SUFFOLK COUNTY PLANNING COMMISSION

AGENDA

STAFF REPORT
SECTIONS A14-14 THRU A14-25 OF THE SUFFOLK COUNTY ADMINISTRATIVE CODE

Applicant: Greentek Living, LLC
Municipality: Inc. Village of Amityville
Location: s/e/c County Line Road (CR 1) and Green Ave.

Site Plan – 5/2/2018

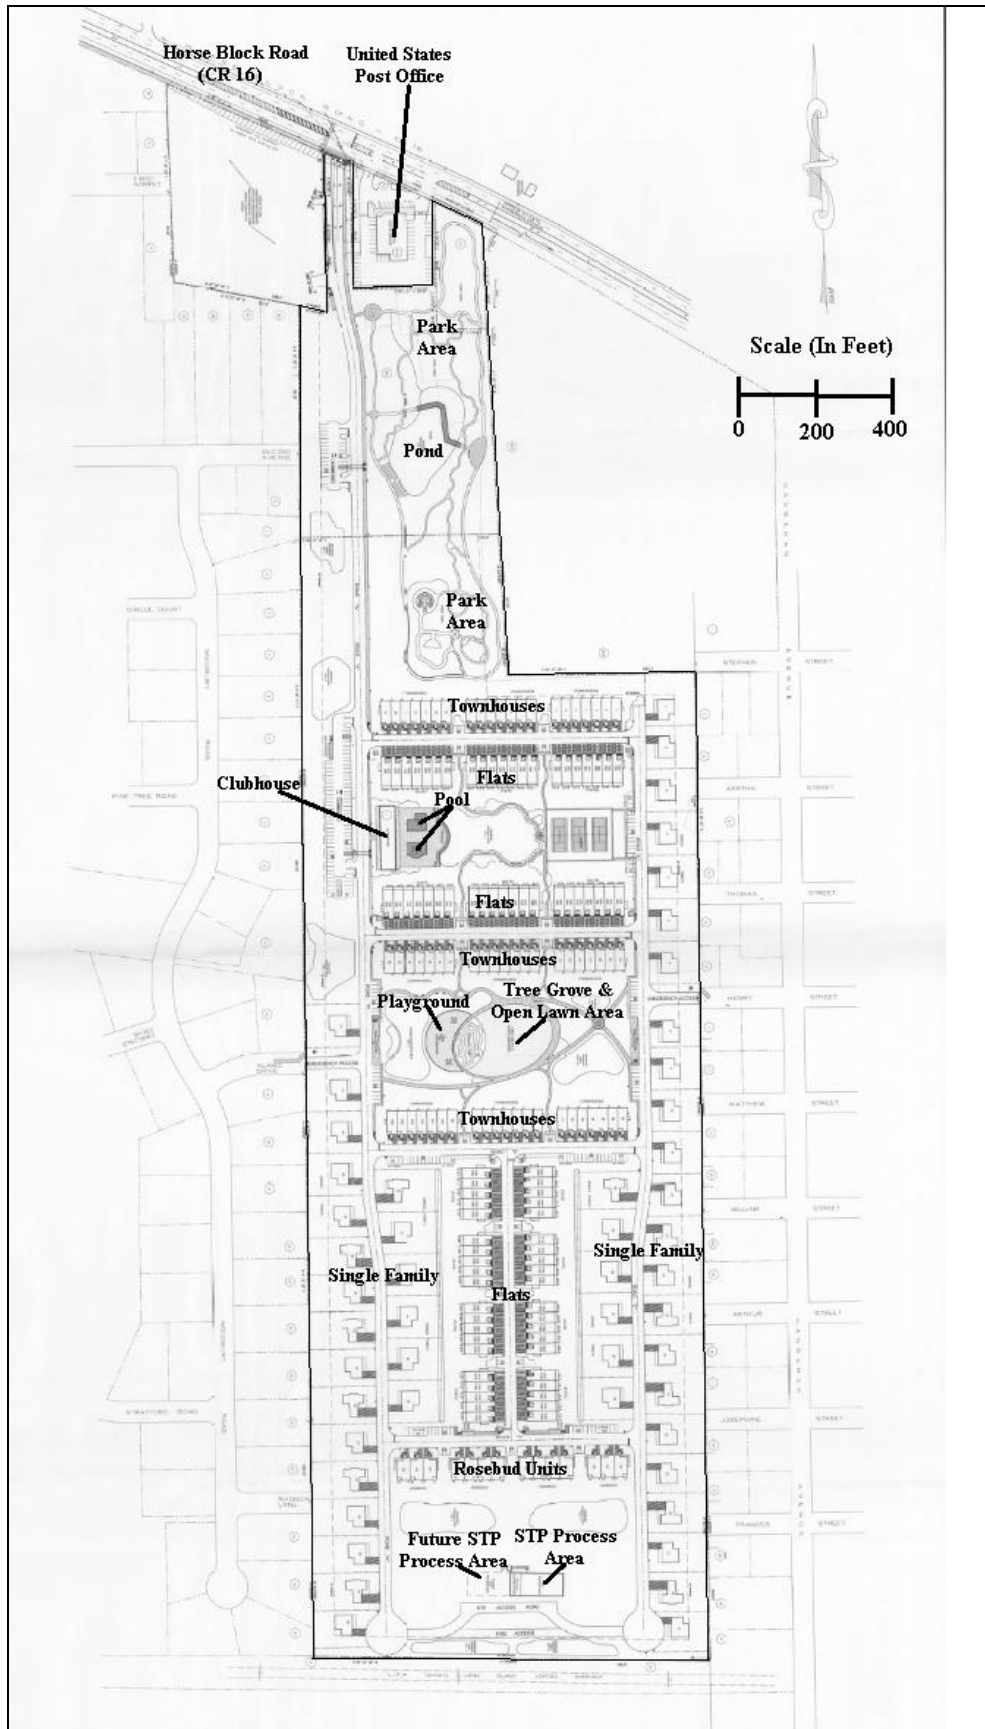
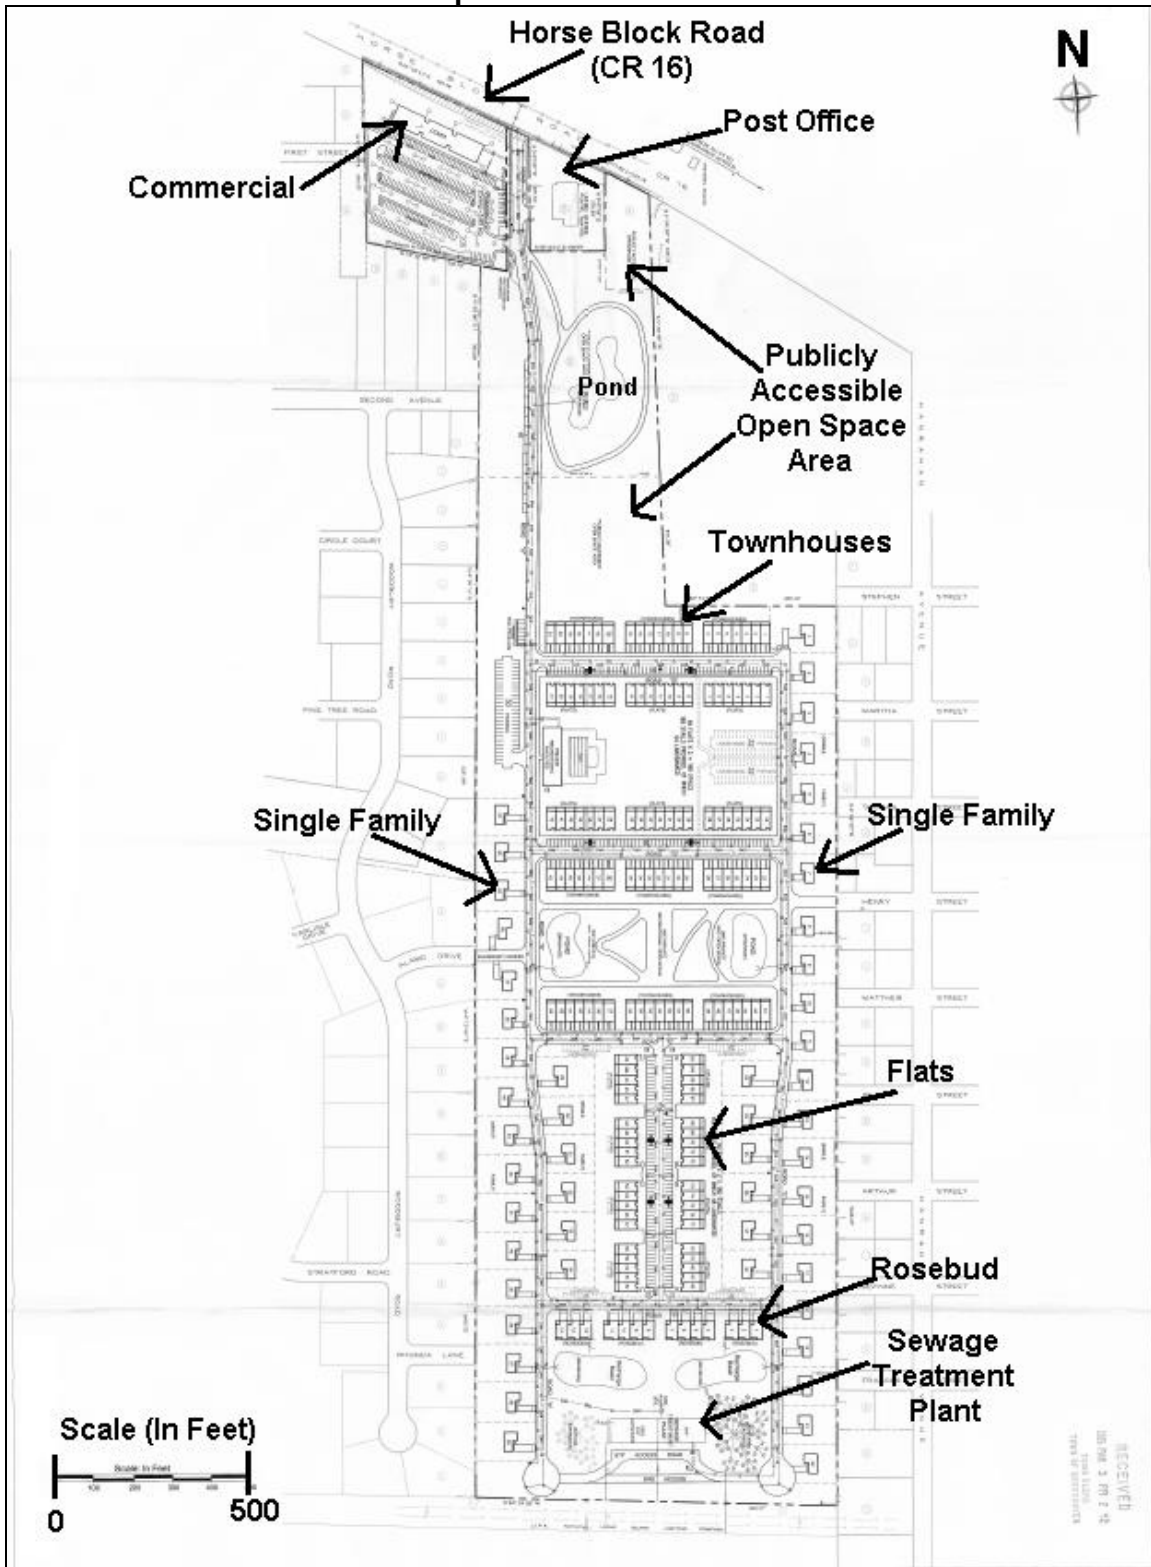
An examination of the currently referred site plan as compared to the prior change of zone and conceptual plan referred to the commission did not reveal any substantial difference between the two maps.

Consistent with the prior Suffolk County Planning Commission review and comments, staff is recommending **approval of the site plan** referral and **approval of the land division application** referral for The Arboretum at Farmingville with the following comments:
